**SAFETY EVALUATION REPORT**  
**REVIEW OF APPLICATION TO AMEND LICENSE CONDITION 11.3(C), LICENSE SUA-1601,**  
**STRATA ENERGY, INC. ROSS IN SITU RECOVERY FACILITY, CROOK COUNTY, WY**

**DATE:** January, 2018

**DOCKET NO.:** 040-09091

**SITE:** Ross ISR Facility, Crook County, Wyoming

Figure 1. Well Yields of 0.5 GPM as a Function of Available Water Column, Transmissivity and Storativity

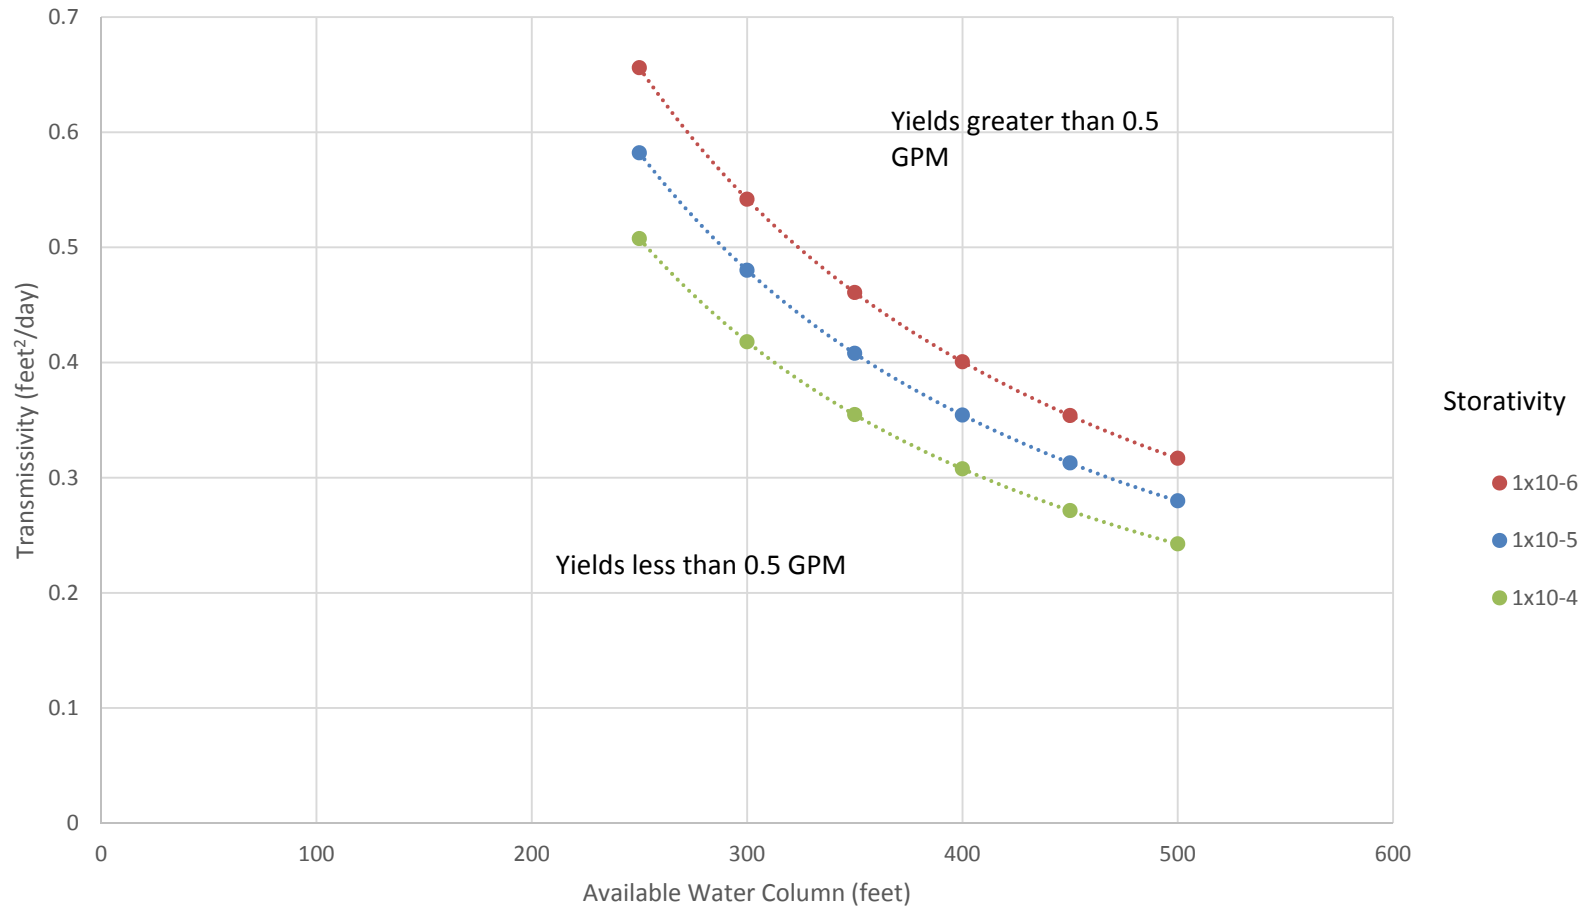
The NRC staff finds Strata's proposed criterion 5 acceptable because it is based on established State of Wyoming criteria. Furthermore, staff find the procedures used by Strata acceptable (with one caveat listed below) because they quantify a sustainable yield for a specific well based on (1) estimates of the hydraulic properties for the aquifer in the vicinity of the well using established slug testing methodology, (2) an appropriate period for sustainable pumping, (3) utilizing actual water column in the pumping well available for cumulative drawdown, and (4) established models for non-equilibrium radial flow to a well. The assumed parameters for Strata's analysis include storativity of the aquifer ( $1 \times 10^{-5}$ ), estimated available water column with a factor of safety (20 feet above the pump intake which is 30 feet above the top of the screened horizon) and the pumping duration (365 days). The measured parameters for Strata's analysis include radius of the well screen (0.4375 feet), radius of the well casing (0.1875 feet), aquifer thickness (13 to 25 feet), available water column (static water elevation minus the maximum safe drawdown elevation) (205.8 to 493.9 feet) (Strata, 2017c). The calculated parameters for Strata's analysis include transmissivity of the aquifer and well yield. The NRC Staff finds that the assumed and measured parameters are appropriate and confirmed that Strata's calculations for the well yield are correct using Strata's assumed, measured and calculated parameters (Table 1).

Figure 2. Examples of Curve Fitting to Strata’s Data and Estimation of Time to 0.25 Recovery

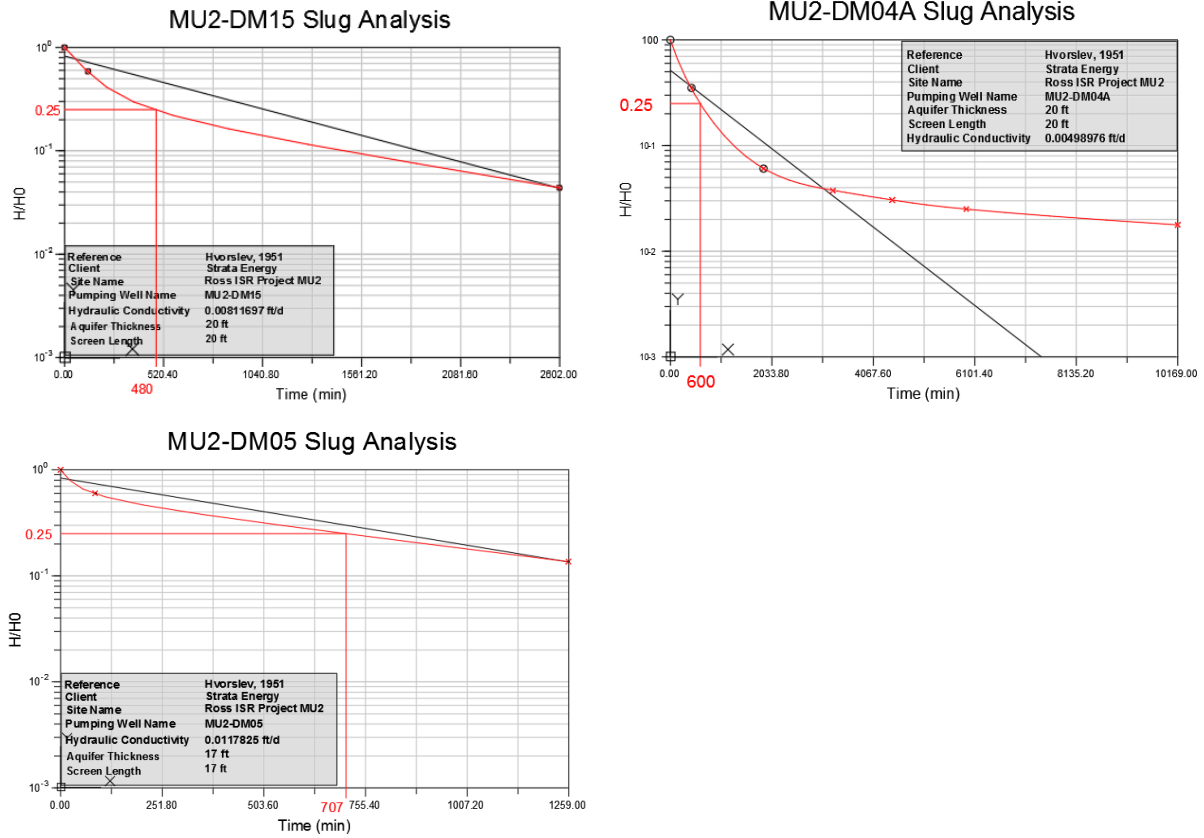
To establish whether Strata's proposal to eliminate any wells from monitoring was based on a flawed analysis, the NRC staff verified Strata's calculations by using the Cooper and Papadopulos methods to establish a transmissivity. The method typically consists of fitting the observed data to a model type curve and then establish a match point between the observed time and dimensionless time for the model curve (Dawson and Istok, 1991; Fetter, 1980). Because of the limited data, the NRC staff used a variant of the method by obtaining a match point for a selected normalized head. In this case, the NRC staff used a normalized head that was 25 percent of the initial head. To establish the normalized 25 percent head, curves were fitted to the data using Strata's graphs from the mine unit reports (for examples, see Figure 2).

The NRC staff determined that the data for wells MU2-DM01, MU2-DM05 and MU2-DM15 was insufficient or had sufficient uncertainty that the verification was deemed unnecessary and the wells were included in any proposed monitoring program. For the remainder of wells, the NRC staff estimated the time to the 25 percent normalized head varied between 0.2 and 13.7 days (Table 2).

Time to the 25% recovery during a slug test is based on a curve fitted by staff to Strata's data (see Figure 2).

Figure 4. Mine Unit 1 and 2 Wells exceeding the Yield Criterion

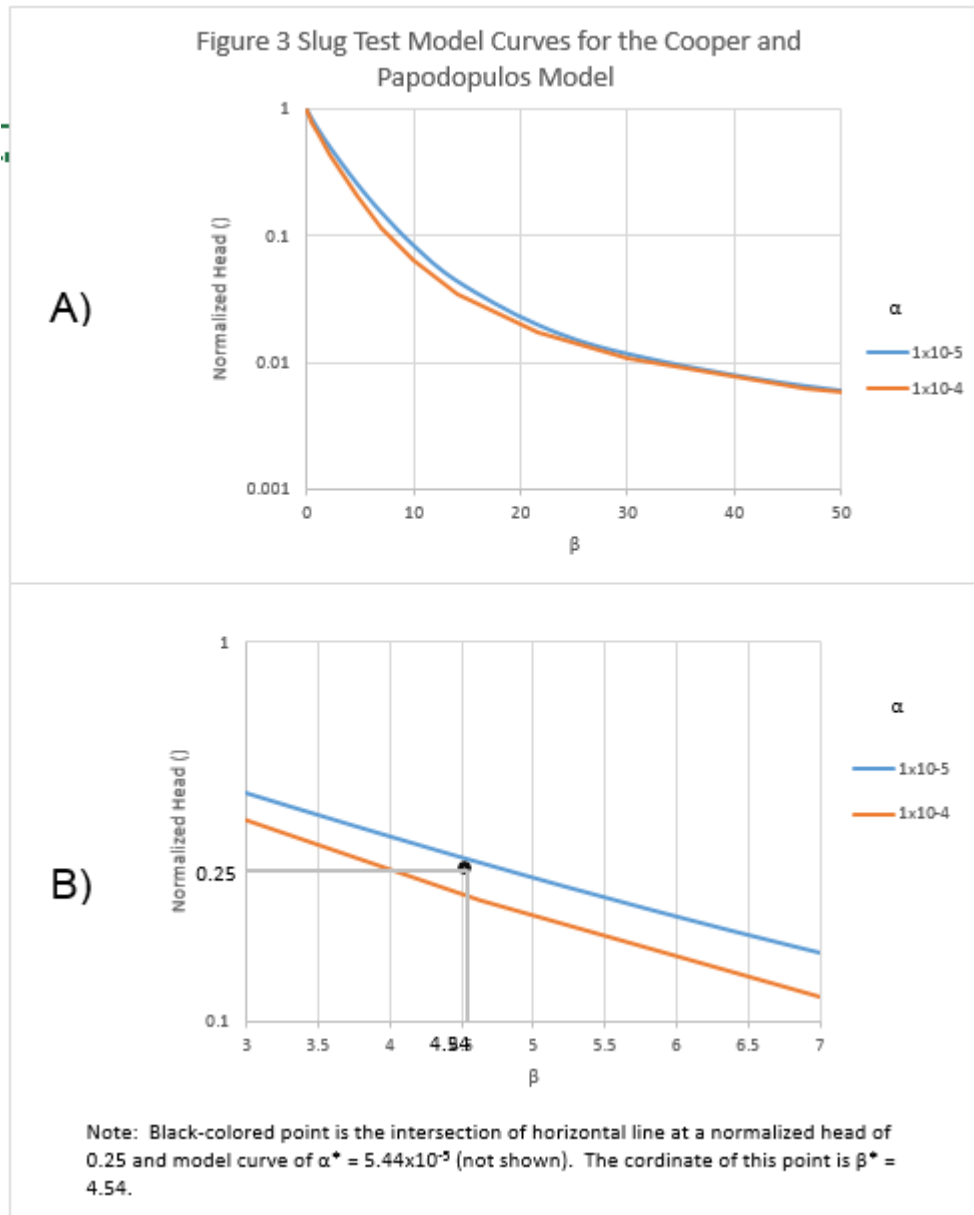
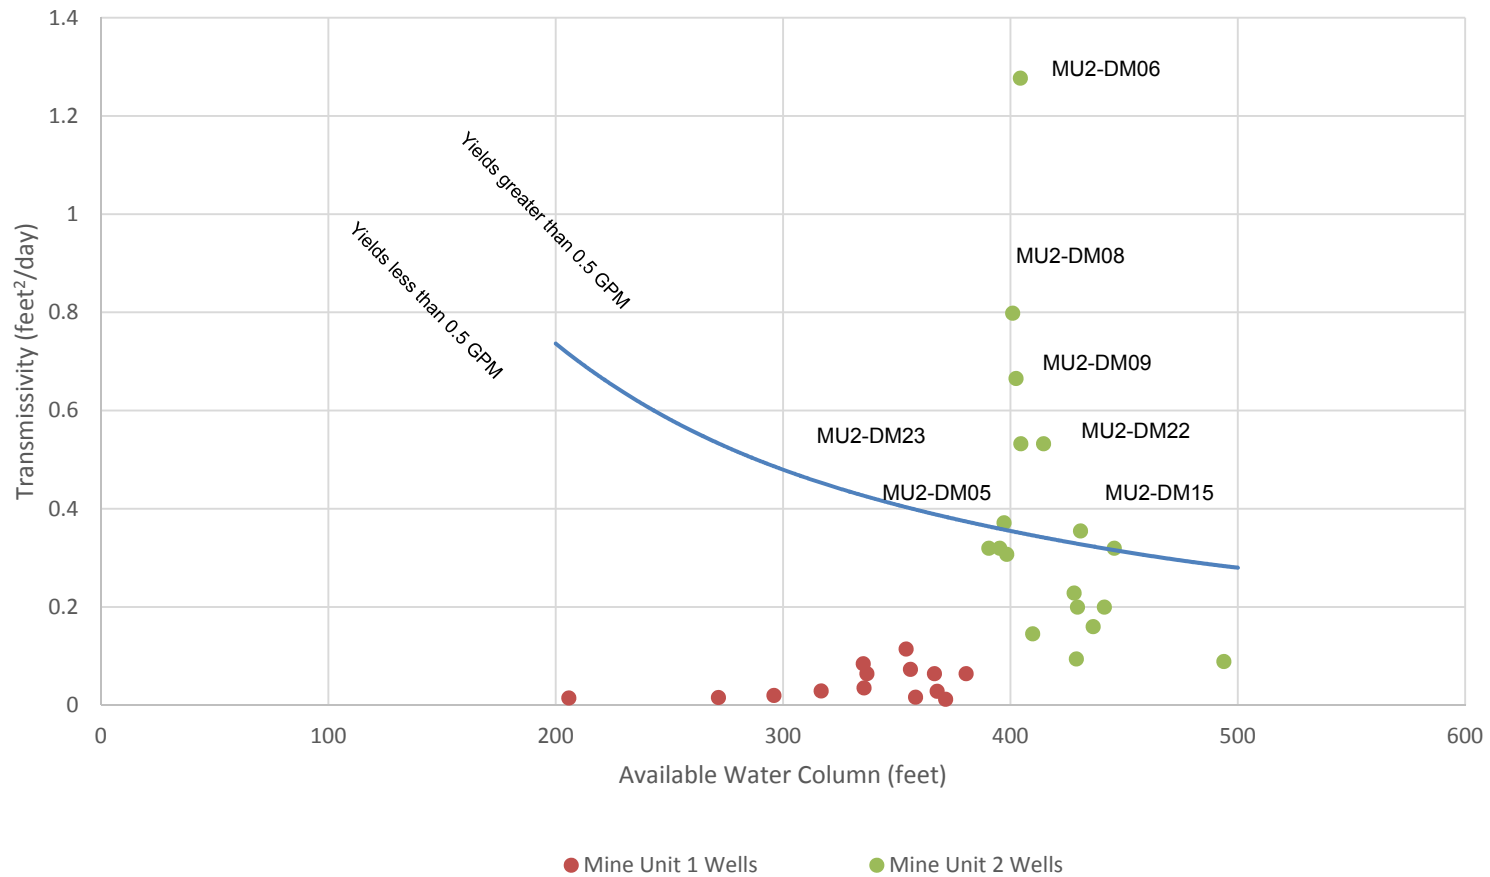
The calculated transmissivities through the verification process varied from 0.01 to 1.28 square feet per day (Table 2). Using the estimate of transmissivity developed through the verification process, a safe yield was determined for each well using the method described above (Table 2). The NRC staff's estimate of the transmissivity during the verification process was consistent with Strata's calculations (within 0.05 square feet per day) for all wells in Mine Unit 1 and wells MU2-DM02, MU2-DM11, MU2-DM14, MU2-DM16 and MU2-DM19. For wells MU2-DM04a, MU2-DM12a, MU2-DM17, MU2-DM18, MU2-DM20 and MU2-DM21, staff's verification transmissivity differed from Strata's calculation (greater than 0.05 square feet per day) but did not result in a predicted well yield greater than 0.5 gpm. For those wells, staff finds that that Strata's conclusions are valid (Figure 4). For wells MU2-DM-06, MU2-DM-08, MU2-DM-09, MU2-DM-22 and MU2-DM-23, staff's verification transmissivity resulted in a predicted well yield greater than 0.5 gpm and thus did not verify Strata's calculations.

Therefore, the NRC staff finds that all DM unit wells in Mine Unit 1, and the DM unit wells in Mine Unit 2 except wells MU2-DM01, MU2-DM-05, MU2-DM-06, MU2-DM-08, MU2-DM-09, MU2-DM15, MU2-DM-22 and MU2-DM-23, have a predicted yield less than WDEQ/LQD criterion of 0.5 gpm and recommends those wells be removed from the monitoring program as requested by Strata. Staff finds that predicted well yields for wells MU2-DM01, MU2-DM-05, MU2-DM-06, MU2-DM-08, MU2-DM-09, MU2-DM15, MU2-DM-22 and MU2-DM-23 cannot be verified and thus continued monitoring is required (i.e., Strata's request is denied for these wells). Strata may elect to re-perform slug tests at the wells that yield insufficient data and resubmit a request for staff to evaluate the new data in the future.

- Mine Unit 1: Monitoring at all wells is discontinued.
- Mine Unit 2: Monitoring is required at wells MU2-DM01, MU2-DM05, MU2-DM06, MU2-DM08, MU2-DM09, MU2-DM15, MU2-DM22 and MU2-DM23
